February 5, 2016
Serial: HNP-16-011

Subject: Response to Request for Additional Information Regarding Harris Nuclear Plant License Amendment Request to Revise Technical Specifications by Relocating Specific Surveillance Frequency Requirements to a Licensee Controlled Program (TAC MF6583)

Response to Request for Additional Information Regarding Harris Nuclear Plant License
Amendment Request to Revise Technical Specifications by Relocating Specific Surveillance
Frequency Requirements to a Licensee-Controlled Program

TABLE 4.3-7 (Continued)

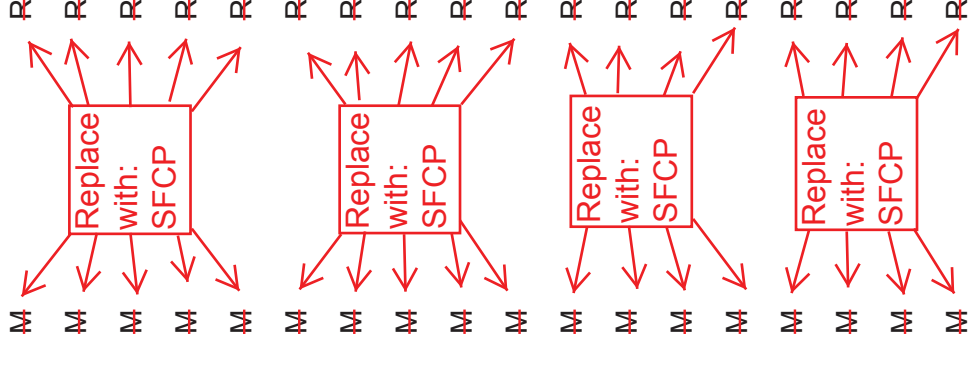
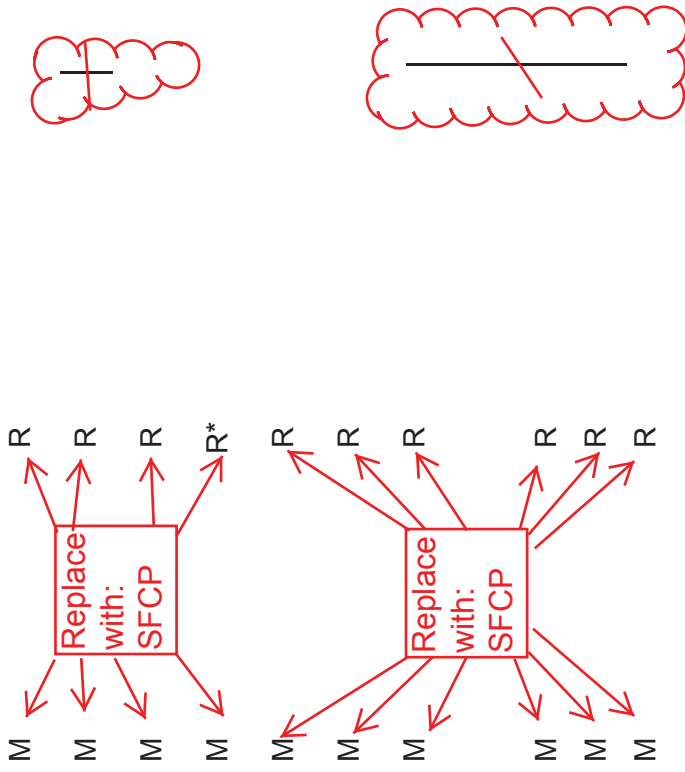
Do the markups for HNP SR Tables 4.3-6 and 4.3-7 mean that each instance of either "M," "R," or "Q" will be replaced with "SFCP?" For example, these markups are unclear and differ from the markups in HNP SR Table 4.3-3 where each instance of a SR table letter frequency designator is replaced with "SFCP." Please explain or provide a clearer markup of HNP Tables 4.3-6 and 4.3-7.
